SUBDIVISION COMMITTEE REPORT

PROJECT NUMBER **HEARING DATE**
R2014-01586 TBD

Tentative Tract Map No. 072939
Conditional Use Permit No. 201400179
Oak Tree Permit No. 201400027
Environmental Assessment No. 201400125

183 & 205 East Palm Street, Altadena

PROPOSED PRIVATE DRIVE AND FIRE LANE
1" = 10'

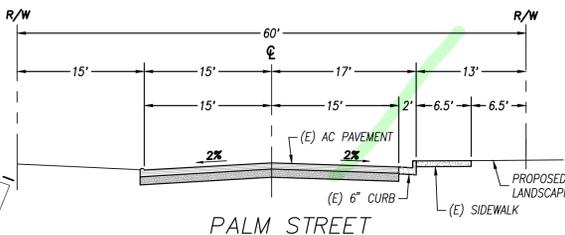
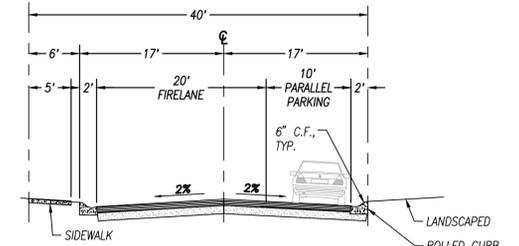
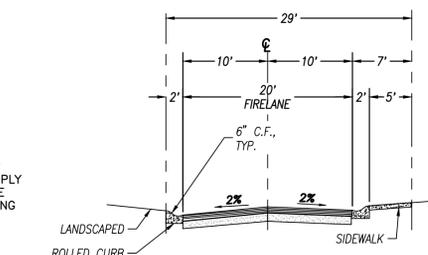
As previously requested:
 The proposed driveway needs to be perpendicular to the curb line.
 The distance from the turn out to the property line is 20 ft. min.
 Provide a turning template to prove that a car can come in and exit the garage.
 Note:
 Show existing curb ramp. The new driveway shall not encroach into the existing curb ramp.

MAJOR LAND DIVISION TENTATIVE TRACT MAP NUMBER 072939 (FOR CONDOMINIUM PURPOSES) LOCATED IN THE UNINCORPORATED TERRITORY OF THE COUNTY OF LOS ANGELES, STATE OF CALIFORNIA EXHIBIT "A"

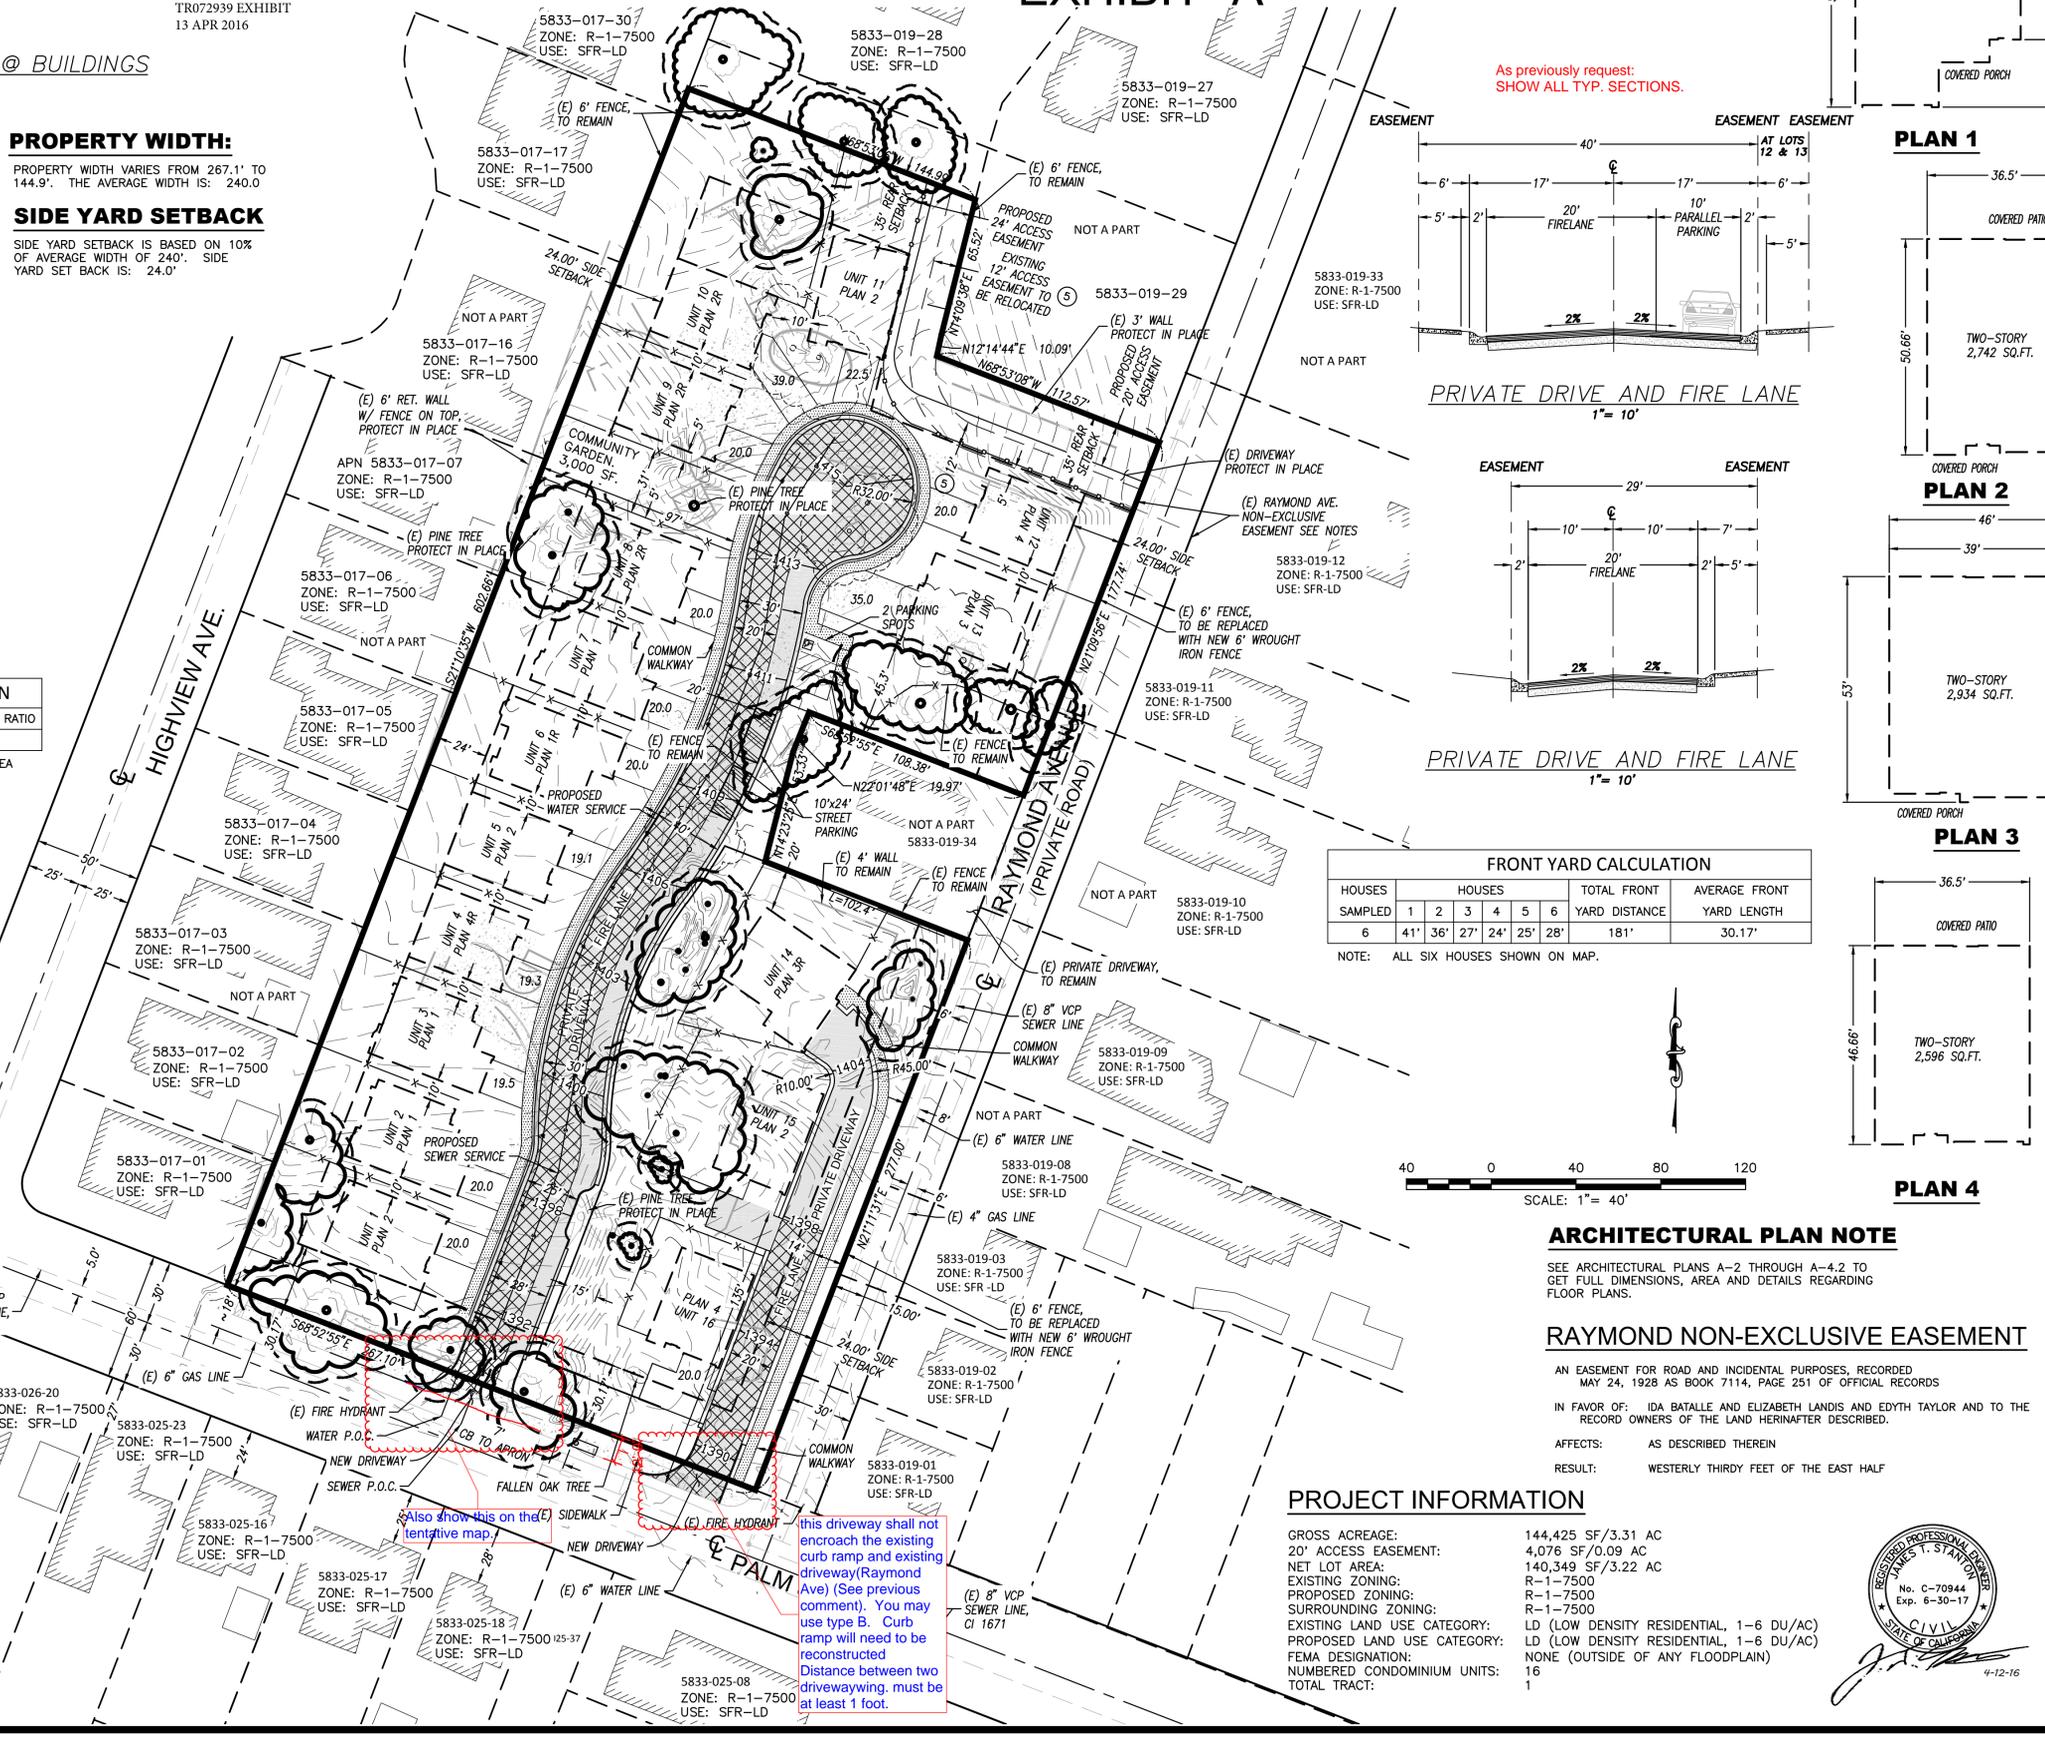
2. There is a discrepancy with the easement information provided on the Exhibit "A". "Project Area" lists 4,076 sq. ft. of the access easement. The lot coverage table lists 9,872 sq. ft. of easement. Clarify the discrepancy.

3. Provide the dimensions for the proposed guest parking spaces.
4. Section A-A states "5' side yard min." A minimum 24 ft. side yard setback is required. Where is Section A-A?

5. Under the Oak Tree Summary, clarify whether the off-site oak trees are "to remain" or "to be removed."
6. For the proposed residences along Raymond Avenue, are you proposing any additional plantings/landscaping?

7. As previously requested, provide copies of all recorded easement documents.
8. There are inconsistencies between the tentative map and the exhibit map. For example, "wall protect in place" is depicted within the proposed 20 ft. access easement. "(E) Fence to Remain" is located within the proposed community garden. Clarify the discrepancies. Ensure to provide the height information for all existing and proposed fences, walls, etc. Are you proposing any walls or fences around the community garden?

- b. As previously requested, label the existing private street easement on Raymond Avenue, along the property frontage, as "to remain".
 - c. The existing wall in the vicinity along the northeasterly property line adjacent to APN 5833-019-029 needs to be removed since it is in the middle of the driveway.

- d. Please label the width of the driveway adjacent to APN 5833-019-029.
 - e. Please clarify the meaning of "Protect in Place". Is there a difference between "Protect in Place" and "To Remain"? Please explain.

- h. Please see attached Sewer review sheet (Comment 3) for comments and requirements.
 - i. Please see attached Water review sheet (Comment 2) for comments and requirements.

3. A revised exhibit map is required to show the following item:
 - a. Show how the proposed development specifically units 14 through 16 is to be served by public sewer and call out the proposed points of connection to the existing public sewer system (previously requested).

- b. Revise the label for proposed onsite sewer line to read "Proposed 8" Sewer Main Line"; this line is currently labeled as "Proposed Sewer Service".

- c. Label existing sewer main line on Raymond Avenue with the PC or CI number (previously requested).

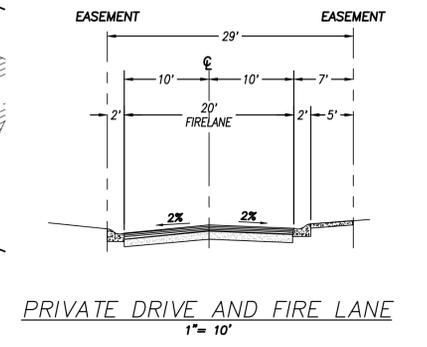
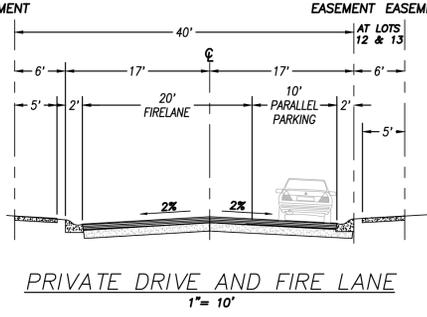
As previously request:
SHOW ALL TYP. SECTIONS.
